TRANS/WP.29/GRSG/2003/2  
30 January 2003

World Forum for Harmonization of Vehicle Regulations (WP.29)

PROPOSAL FOR DRAFT AMENDMENT TO REGULATION No. 52  
(Small capacity passenger vehicles, M2 and M3 category)

Transmitted by the Expert from Spain

Access to driver’s door  
(See paragraph 5.6.2.5.2.)

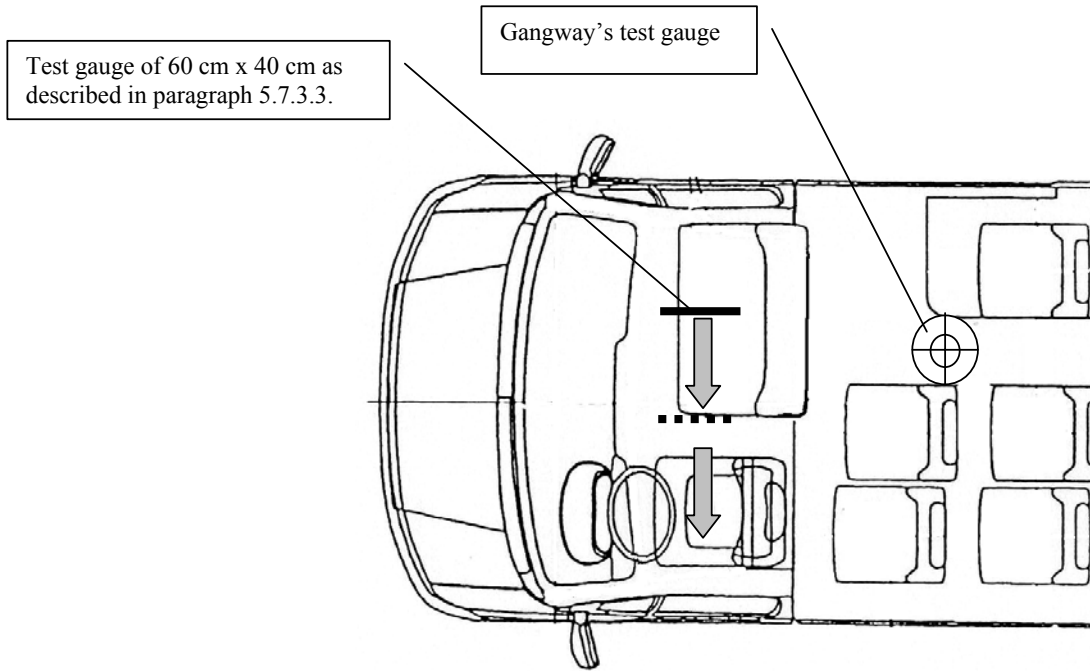
"5.6.2.5.2. The driver's door shall be accepted as the emergency door for the occupants of the seats situated beside the driver's seat **provided that it is possible to move a test gauge from the occupants' seats to the exterior of the vehicle through the driver's door (see annex 3, figure 20).**

**Verification of the access to the driver's door shall be subject to the requirements of paragraph 5.7.3.2., by using the test gauge having a dimension of 600x400 mm, as described in paragraph 5.7.3.3.** The service door provided for the passengers shall be in the side of the vehicle opposite to that containing the driver's door and shall be accepted as the emergency door for the driver;"

Insert new figures 21 and 22, to read:

Figure 22  
Access to driver's door  
(See paragraph 5.7.2.4.2.)

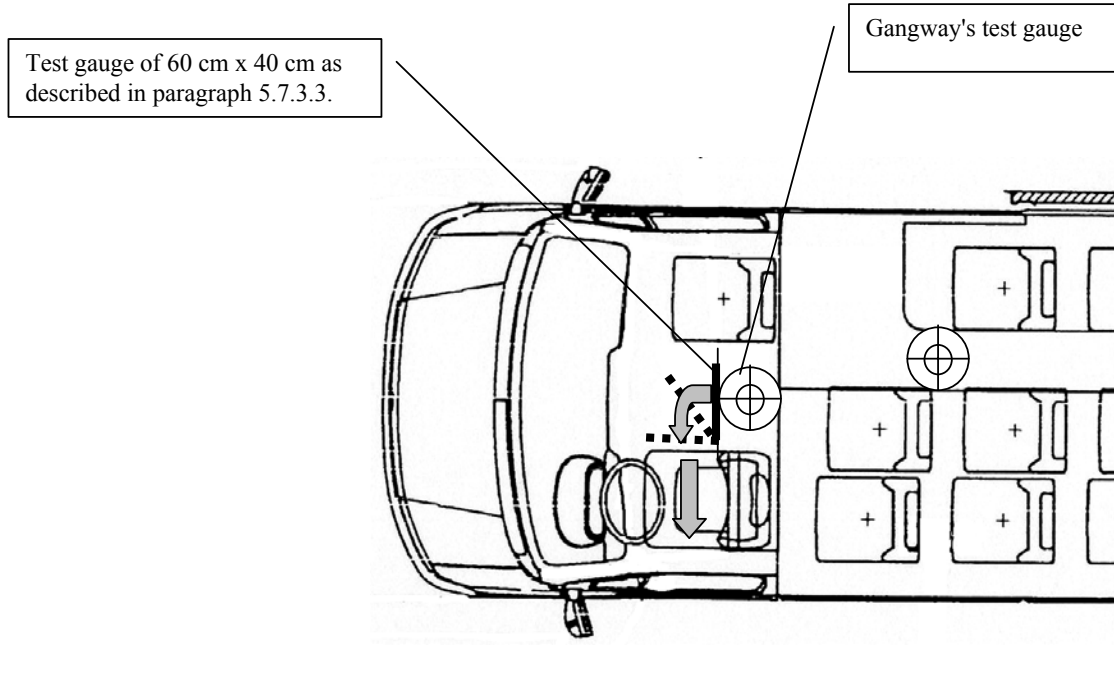
" ..... defined in paragraph 5.6.2.5.2. **and that the space reserved for the driver's seat shall communicate with the main passengers' compartment through an appropriate passage; such requirement shall be deemed to be fulfilled if the test gauge described in paragraph 5.7.5.1. can move unobstructed from the gangway, enabling that the front end of the gauge reaches the vertical plane tangential to the foremost point of the driver's seat back (this seat situated in its rearmost possible position) and, from this plane, the panel described in paragraph 5.6.2.5.2. could be moved to the emergency door in the direction established by such paragraph (see annex 3, figure 21).**"
